MEMORANDUM

TO: DESIGN REVIEW BOARD
FROM: GREORY DAVIS, PLANNER 
DATE: SEPTEMBER 9TH, 1999
SUBJECT: DR99-77 - HIGHLAND PLAZA SIGN PACKAGE

DR 99-77: Sign package for Highland Plaza
SWC Recker Road & Guadalupe Road
P.A.D.: (C-1) Light Commercial

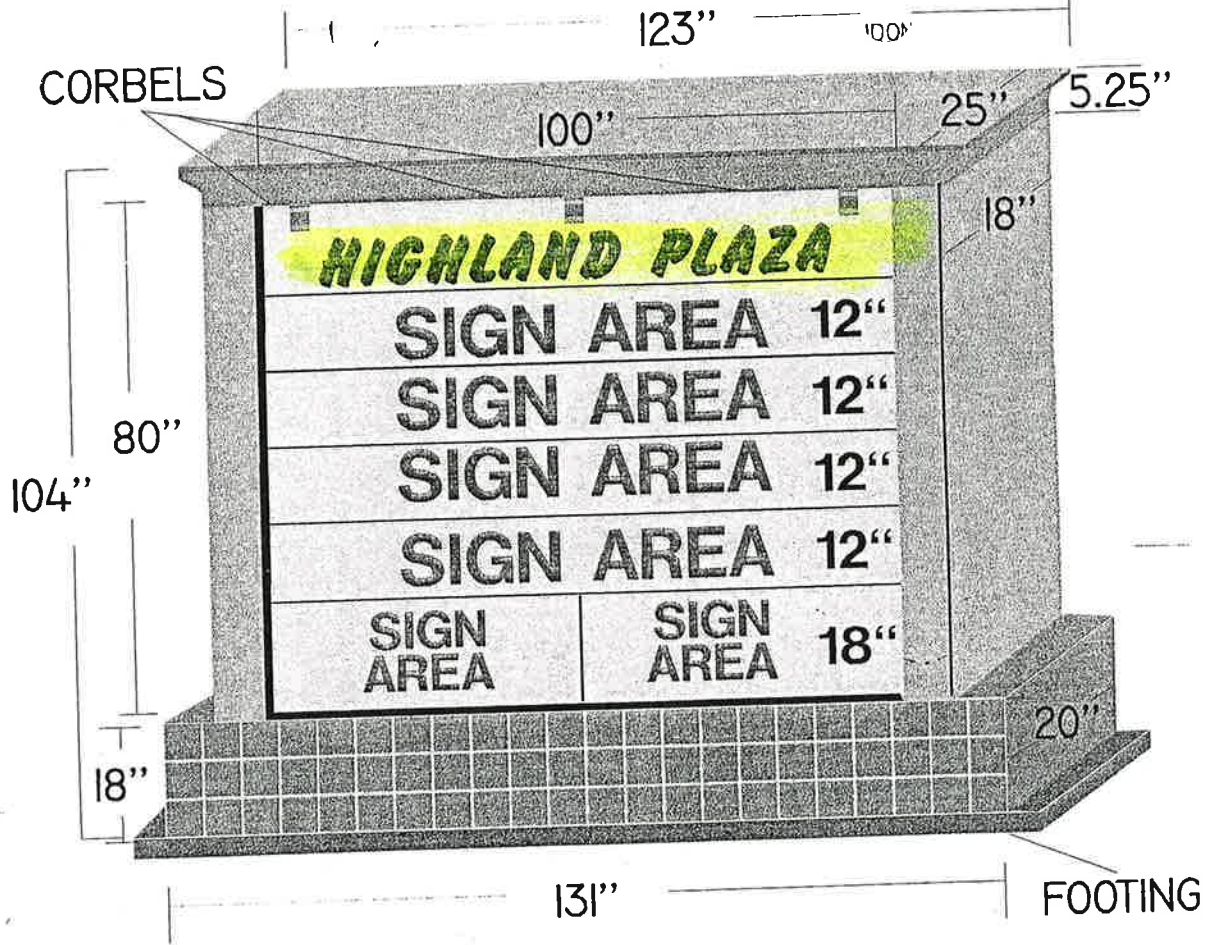
The design of the monument signs should be in conformance with the prevailing architectural design of the center. This center's architectural theme has a very distinctive design. The buildings all have a split-face CMU wainscot, a stucco body painted "Ajo Lily", and a cornice EIFS system featuring corbels. The applicant is proposing a split-face CMU base to match the building. The rest of the sign is proposed to be aluminum with a montex finish. Staff recommends the columns and cornice of the sign be frame construction with a stucco finish that matches the building material. Additionally, the cornice treatment should be extended down creating a backing for the corbels. As proposed, the corbels do not appear to be integrated into the sign face. The corbels should also be increased in size to be at least four(4") inches wide by four(4") inches tall.

The overall height of the sign is proposed to be over eight (8') feet. The applicant has agreed to lower the base of the sign by two (2") inches leaving the sign eight feet six inches (8'-6") in height. Although this height does exceed the maximum height permitted by Code, it is the interpretation of the Planning Department that the portion of the sign above eight(8') feet is an architectural embellishment and is not subject to the height restriction. Therefore, with the aforementioned changes, Staff supports the design of the freestanding signs.

4. The freestanding sign columns and cornice element shall be frame construction with a stucco finish to match the building finish material.
5. The cornice treatment of the freestanding signs shall be extended down four (4") inches, to create a backing for the corbels.

6. The corbel accents shall be increased in size to be at least four(4") inches wide by four(4") inches tall.
7. The maximum height of the freestanding signs shall not exceed eight feet six inches (8'-6") including the cornice architectural embellishment.
